## Comments on "Development of Cross-Polar Orientation-Insensitive Chipless RFID Tags"

O. Rance, N. Barbot, Etienne Perret

**Abstract**— In [1], the authors present a technique for designing resonant scatterers that display a cross-polarization reflection that remains consistent (i.e. non-zero) regardless of the orientation of the target. The authors claim that this property can be obtained simply by duplicating, rotating and arranging the position of a unit cell. We will show in this comment that all the design techniques presented in [1, Sec. III] lead to multiple cancellations of the cross-polarization component of the backscattered E-field. Therefore, the measurement results presented in [1] cannot be justified by the theory presented in section III of the same article.

Fig. 1. Angular coverage of the individual dipoles and of the total unit cell. This figure should be compared with [1, Fig. 3] which uses scalar summation.

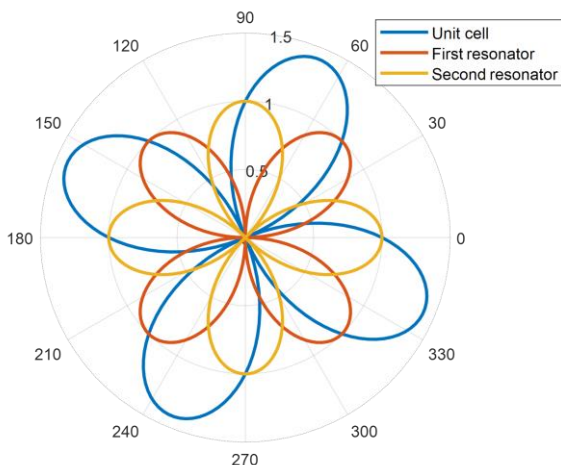
which appears to be zero for  $\theta = 22.5^\circ$  [90°]. The graphical representation of  $S_{vh}(\theta)$  normalized by  $A$  has been plotted in Fig. 1 for comparison with [1, Fig. 3]. The curves are identical for the first and the second resonators but the unit cell exhibits four nulls contrary to the scalar summation presented in [1]. Therefore, the unit cell shows no improvement in terms of angular coverage compared to the individual dipoles.
